**LOST CREEK ISR, LLC**

**Re: Responses to June 22, 2009 Comments Regarding the Lost Creek ISR Application  
TFN 4 6/268**

**RESPONSES to  
WDEQ/LQD 2<sup>nd</sup> ROUND REVIEW  
of  
APPENDICES D5 and D6**

**for the  
LOST CREEK PROJECT  
Wyoming**

**FIGURE D5-1**  
**Regional Geologic Map**  
**Lost Creek Permit Area**

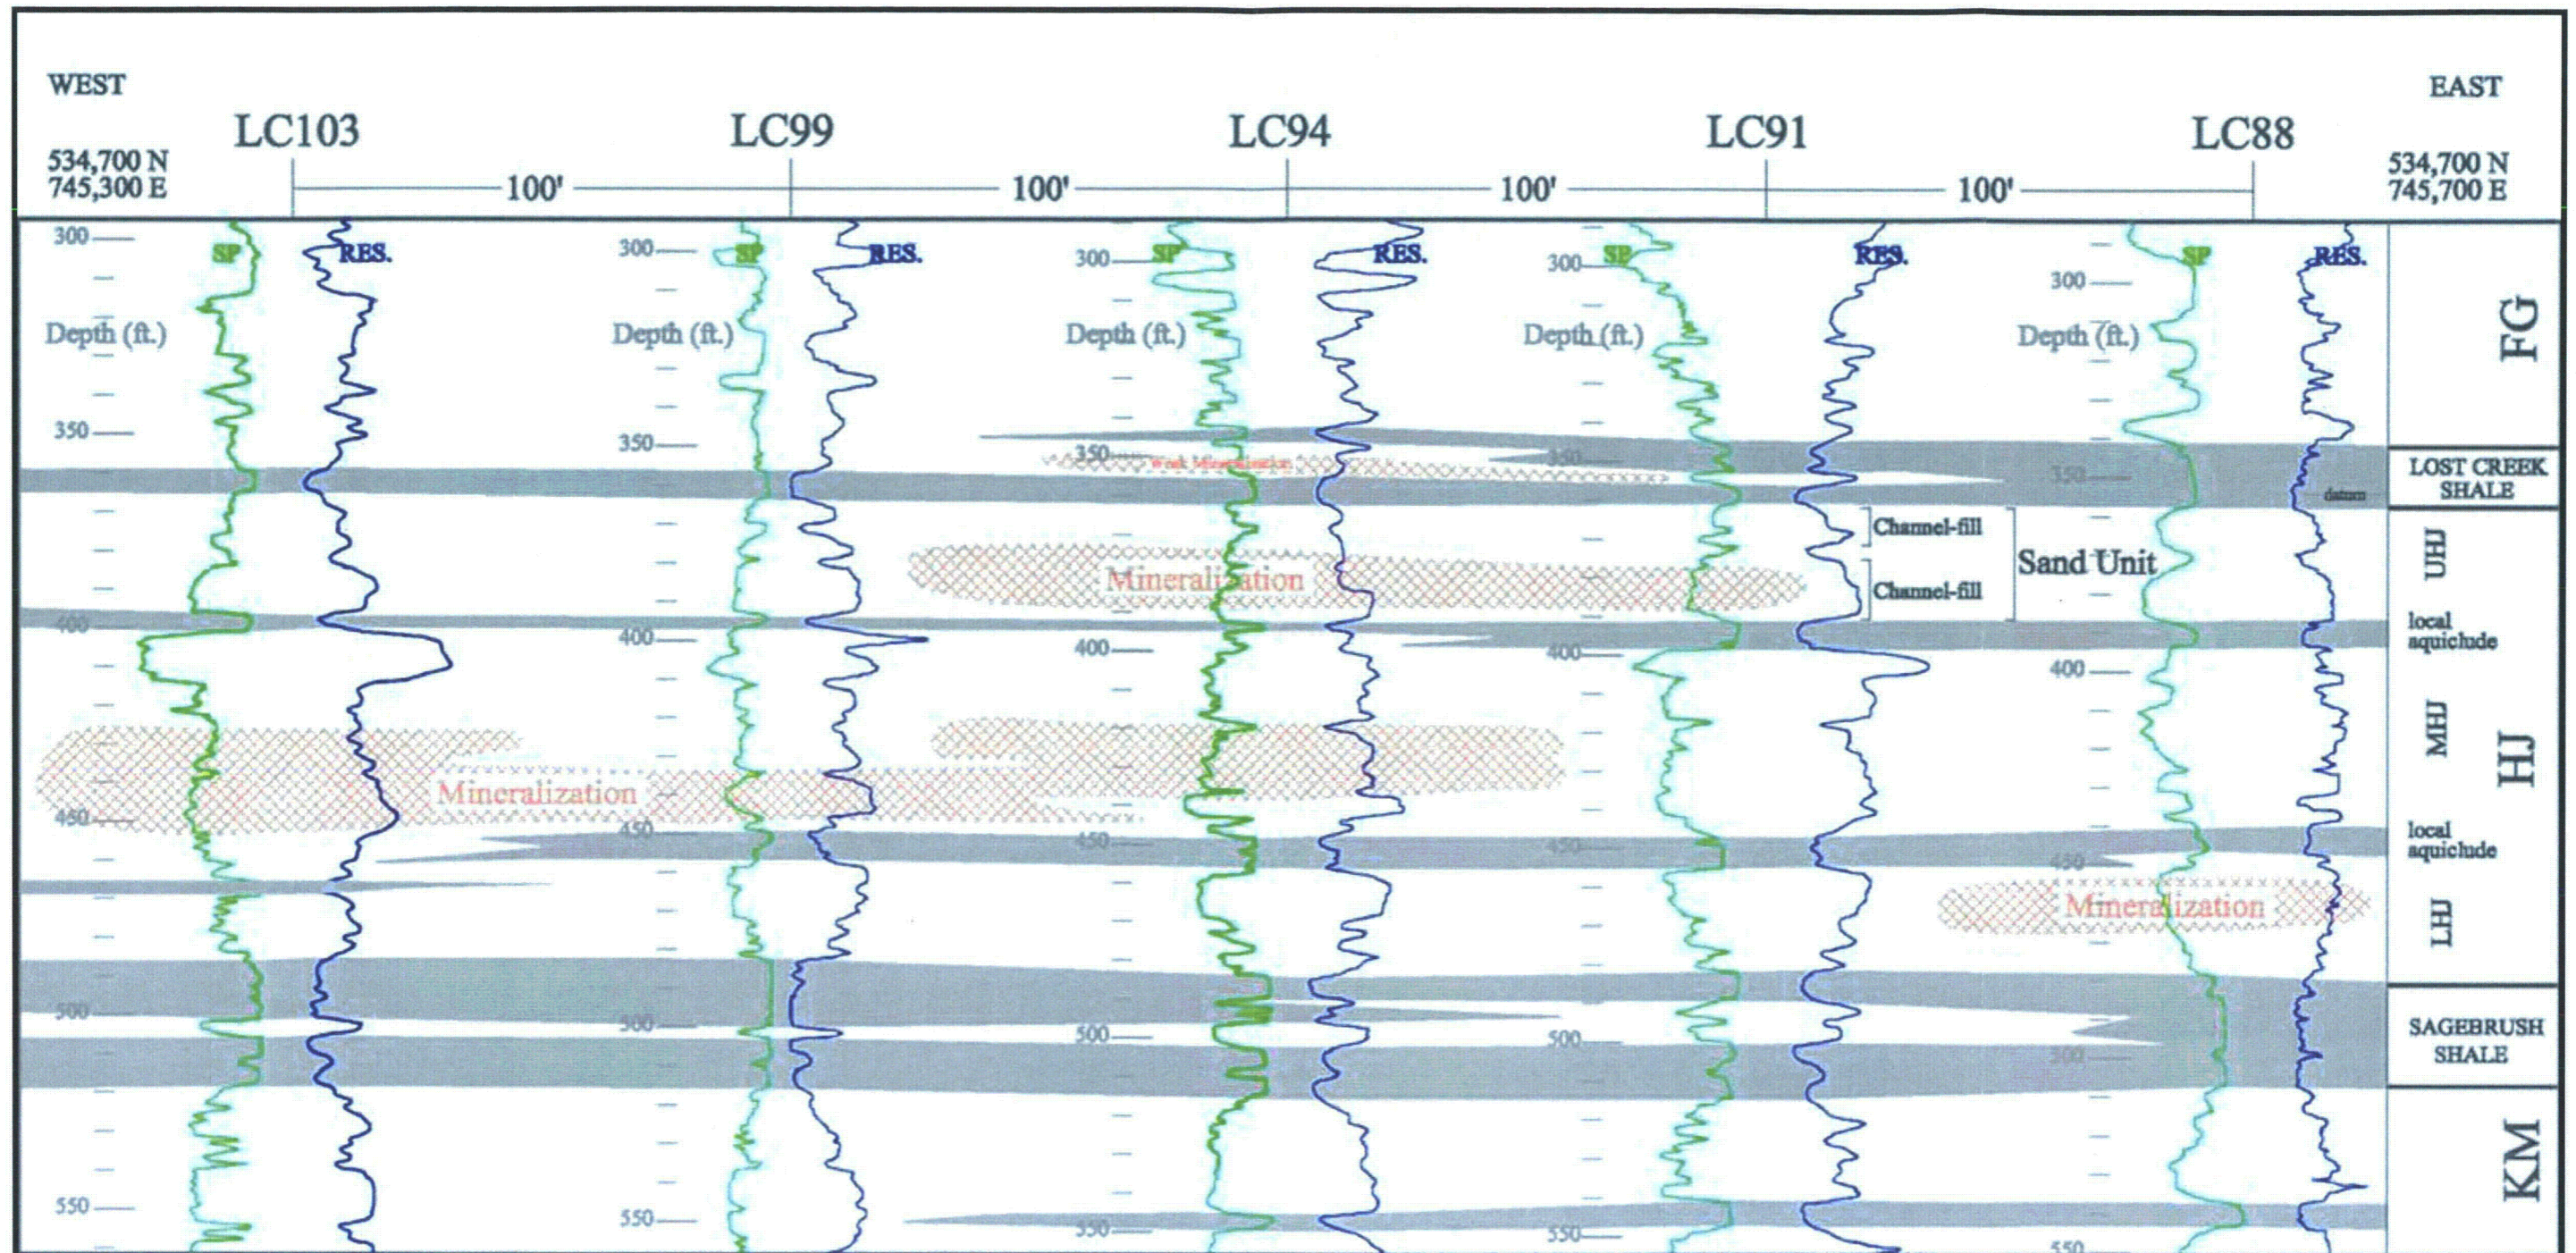
2. LQD (8/08) - *Figure D5-1 is a Regional Geologic Map. This map indicates the faults in the area, but does not indicate the Lost Creek Fault within the permit area. This is a significant and well documented feature within the permit area, and should be indicated on the Figure.*

LQD (6/09) - Figure D5-1 is only intended to depict major regional faults. Since the Lost Creek Fault zone is a minor fault system, it is not illustrated on the regional map. It is, however, illustrated on the property-scale maps. **The legend on Figure D5-1 should be changed to read "Major regional faults".**

LC ISR, LLC (11/09) - The legend on Figure D5-1 has been changed as requested.
